STATE OF HAWAII DEPARTMENT OF TRANSPORTATION HIGHWAYS DIVISION	
INDEX TO DRAWINGS	
RAMP-IF	
STA: 78+17.13 TO STA: 85+37.69	
AIRPORT INTERCHANGE	
F.A.I. PROJECT No. I-HI-1 (174)16	
SCALE: N.T.S.	DATE: SEPT. 1982
SHEET No. I-1 OF 42 SHEETS

Contract Change Order No. 2 - Footing 30F Revision

STATE OF HAWAII DEPARTMENT OF TRANSPORTATION HIGHWAYS DIVISION	
REVISED FOOTING 30F DETAIL	
RAMP IF	
AIRPORT INTERCHANGE E.A.I. PROJ. NO. I-HI-1 (174) 16	
SCALE: AS SHOWN	DATE: JULY, 1983
SHEET NO. 8A OF SHEETS

LIMITS OF STRUCTURAL EXCAVATION AND BACKFILL

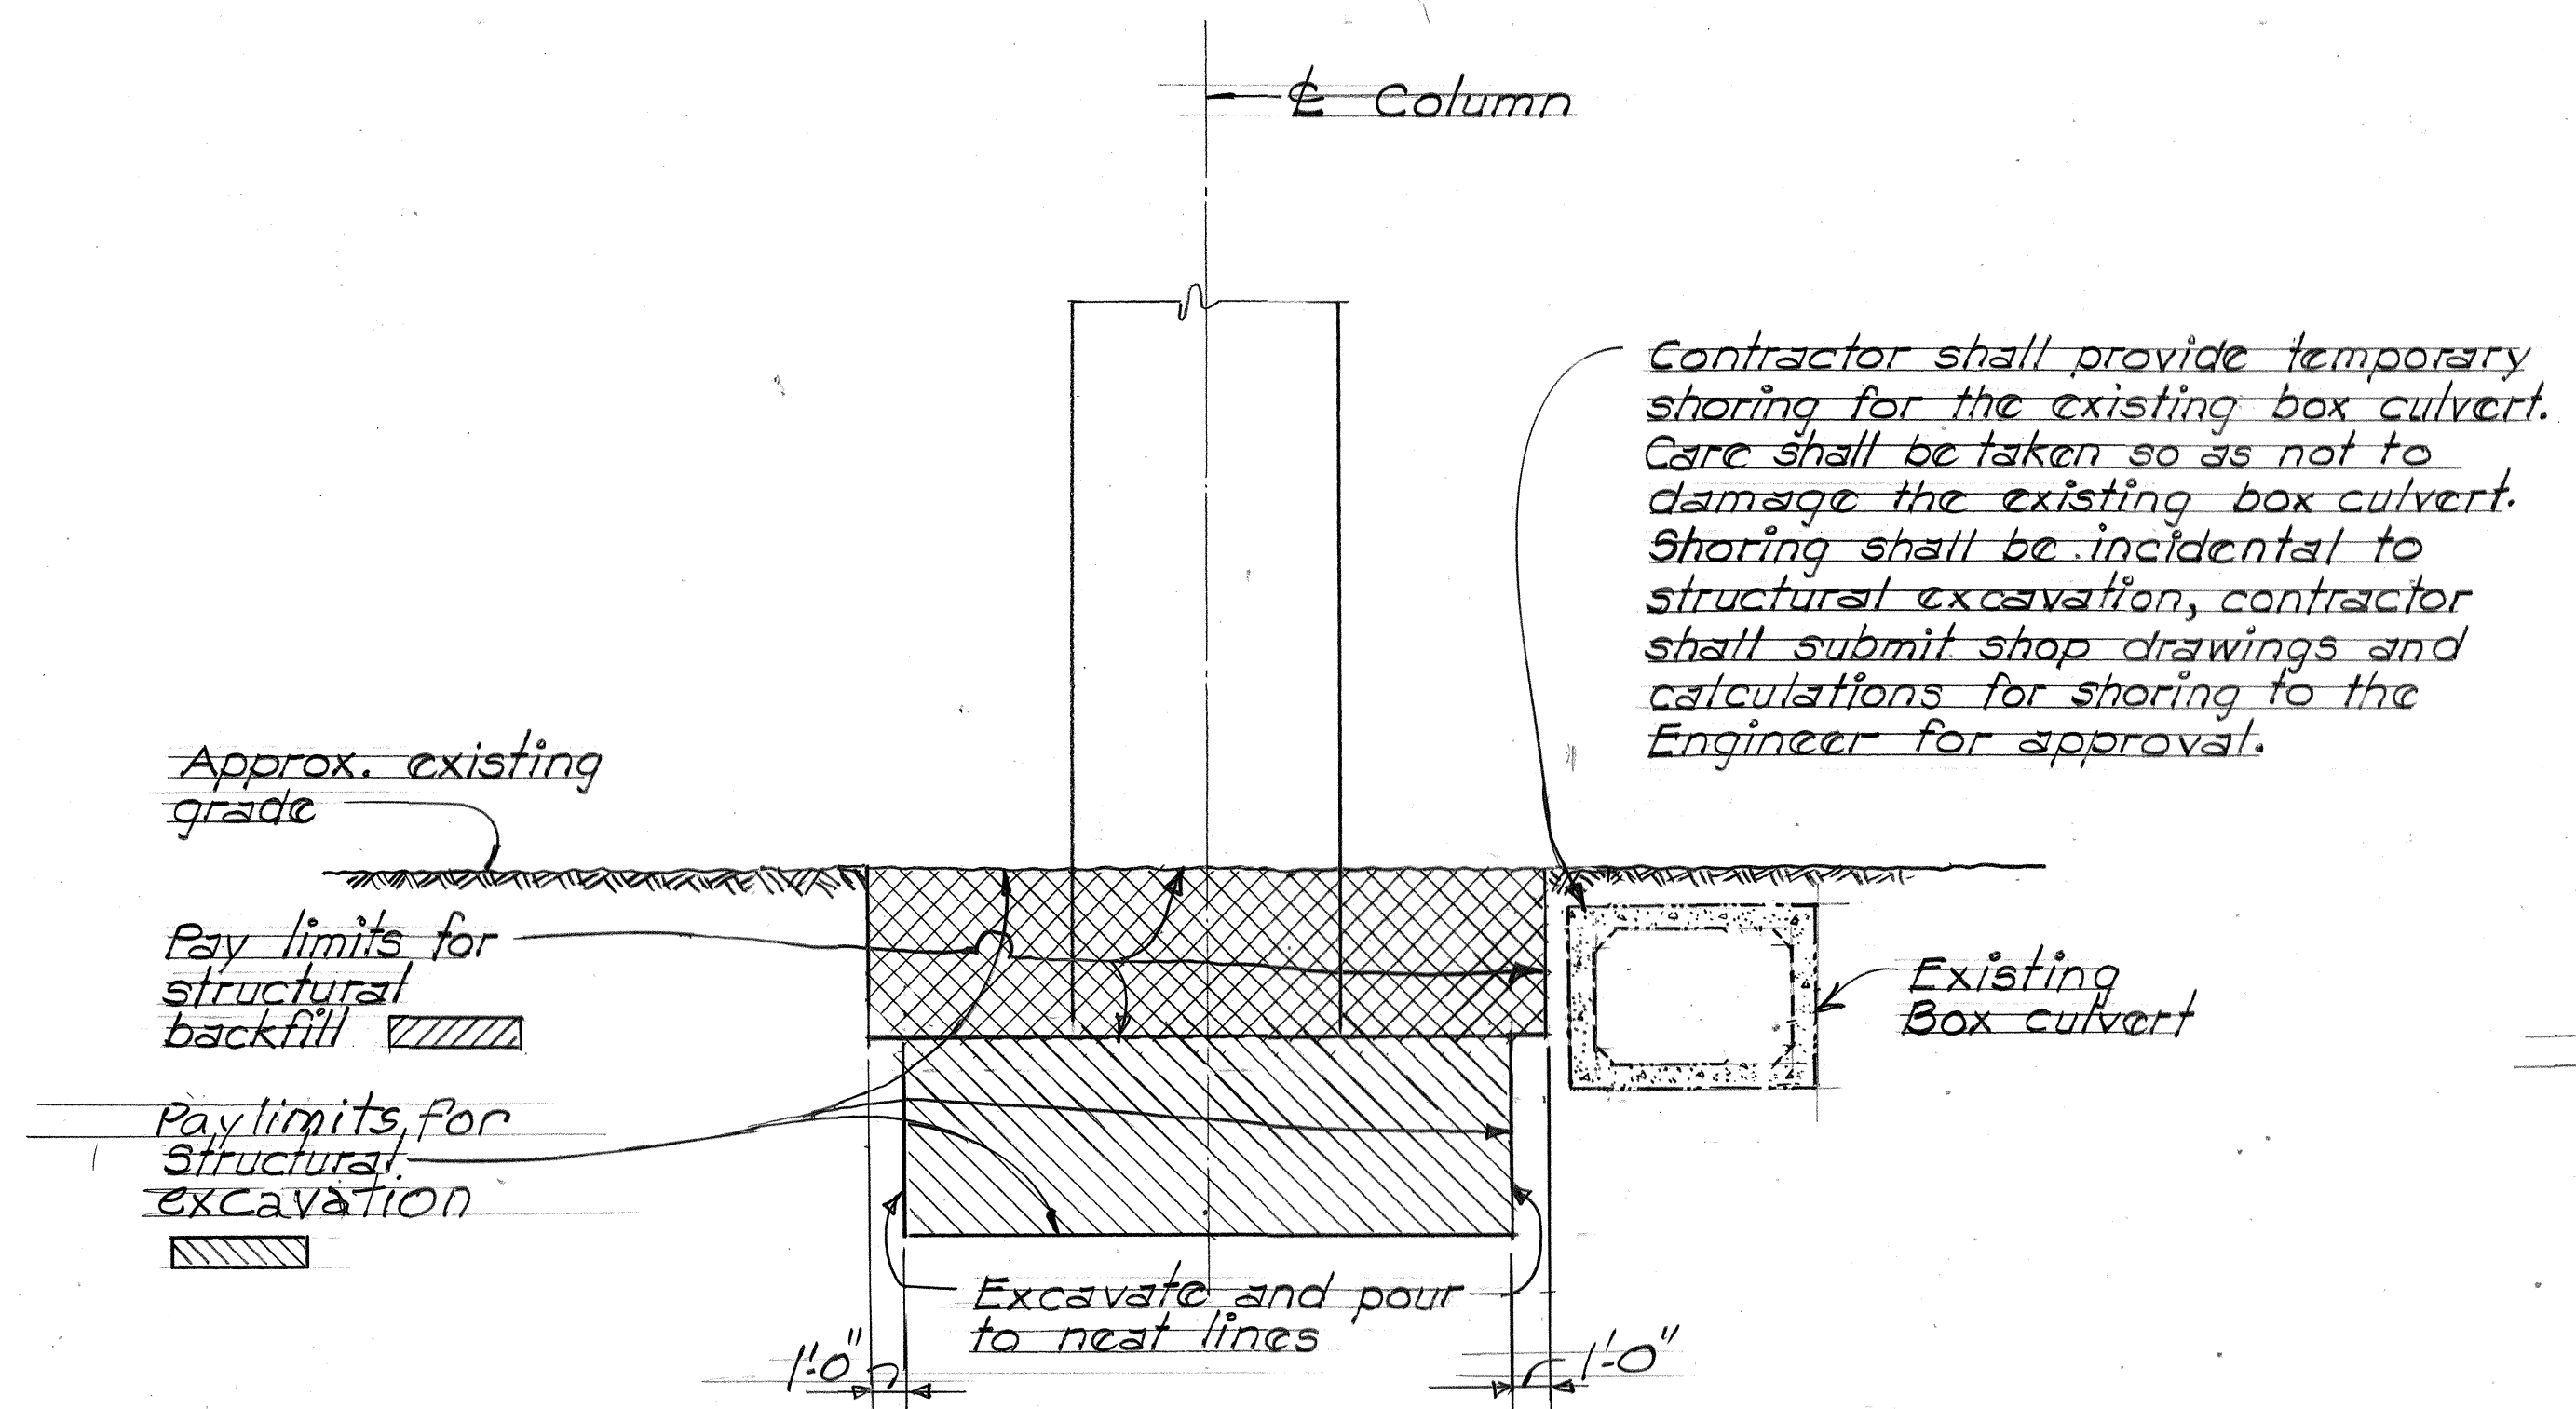
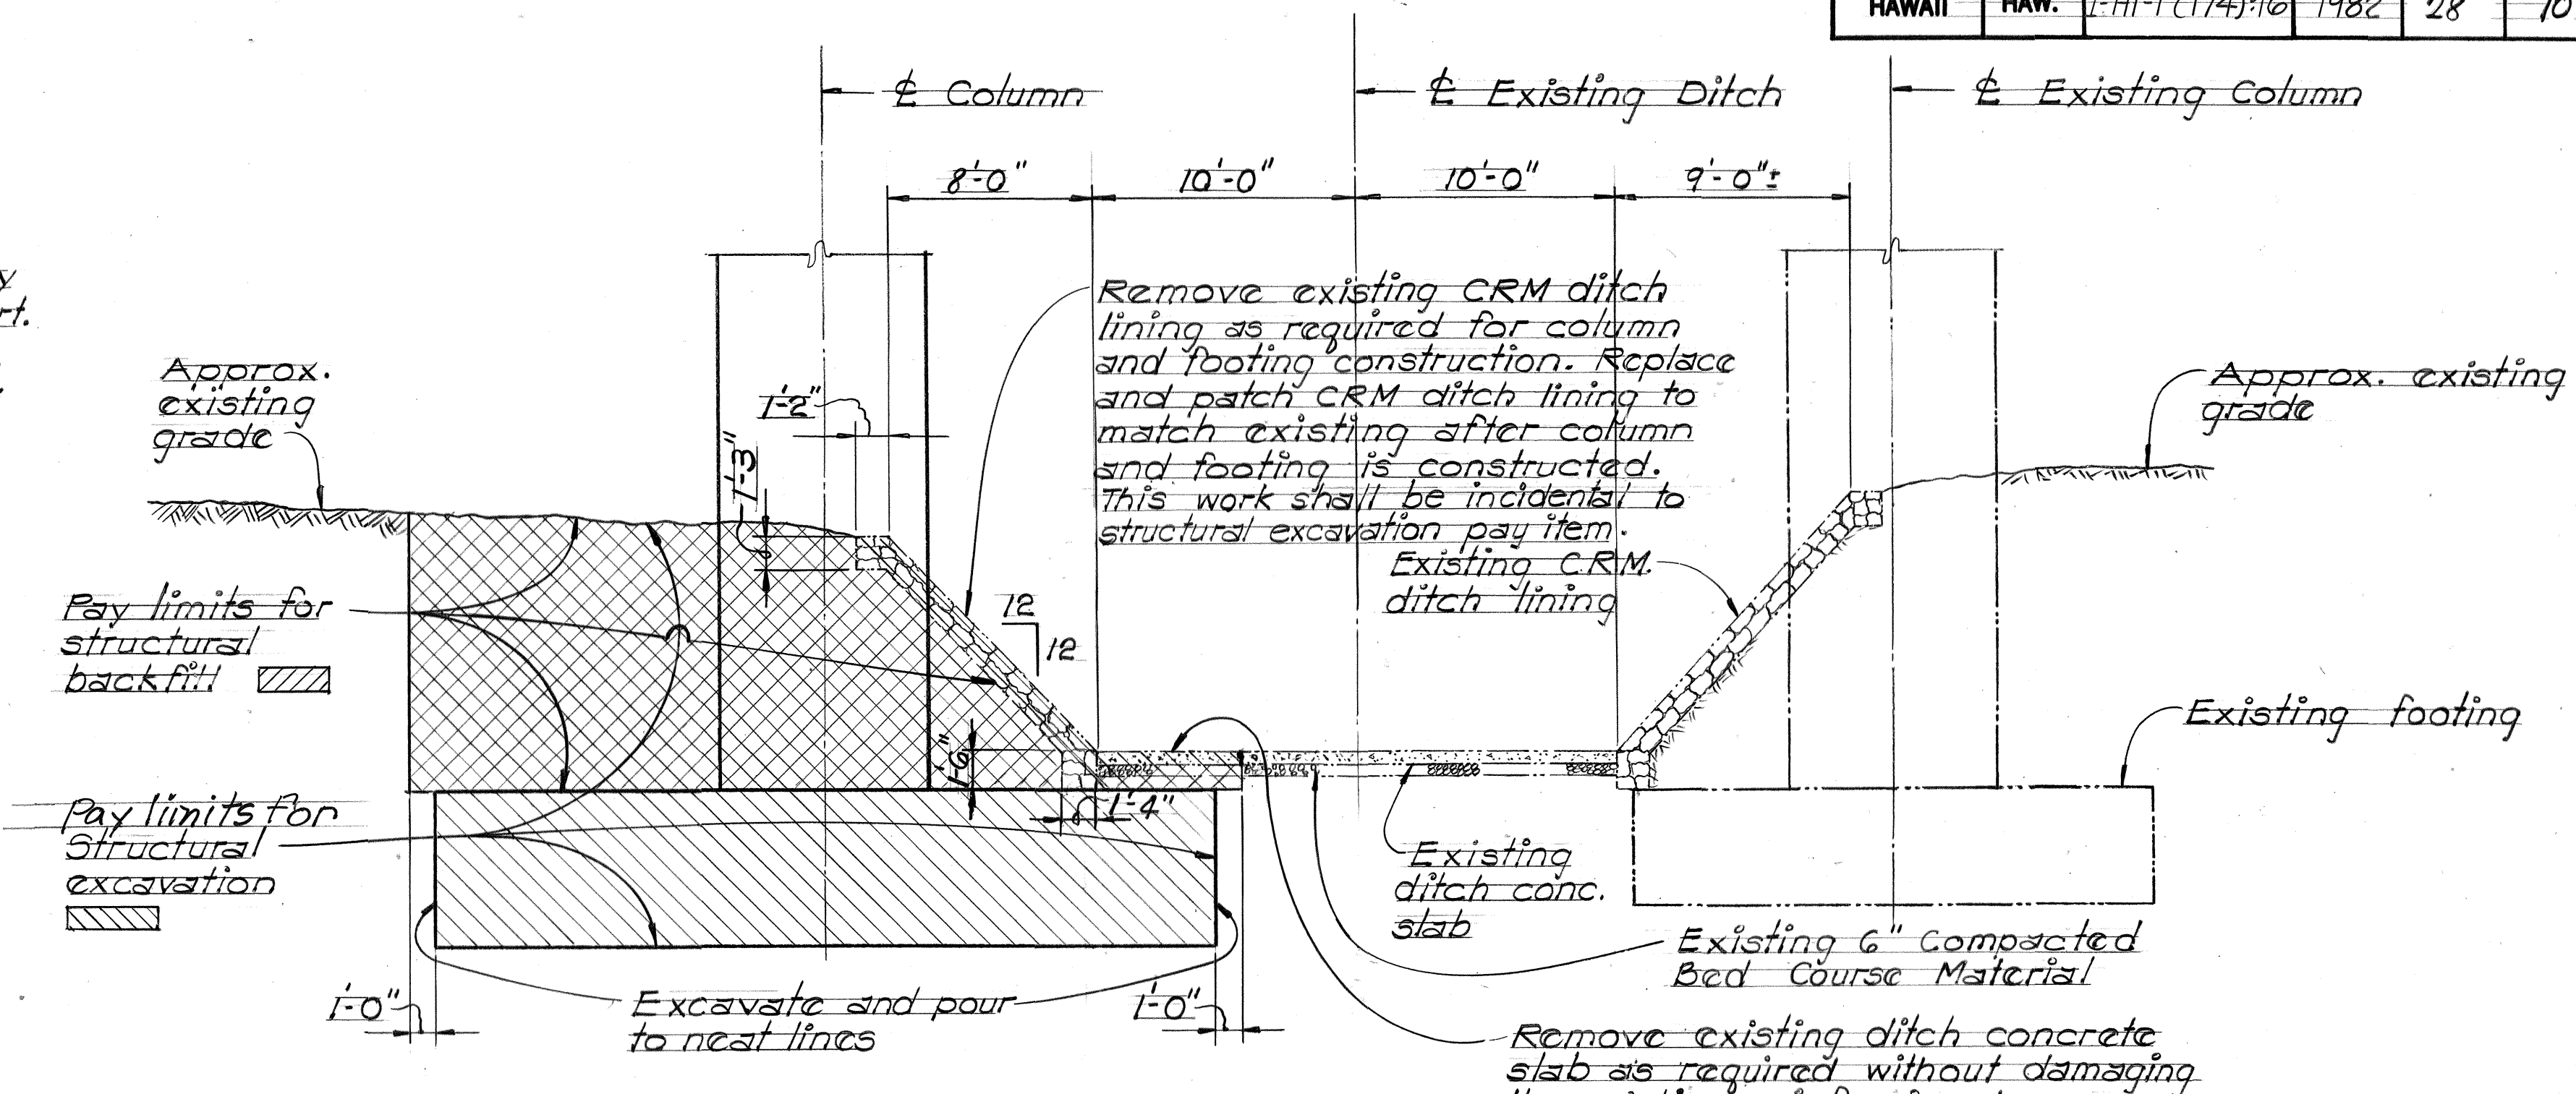
*CCO 3 For No. 32
CCO 3 1st Supp. For No. 33
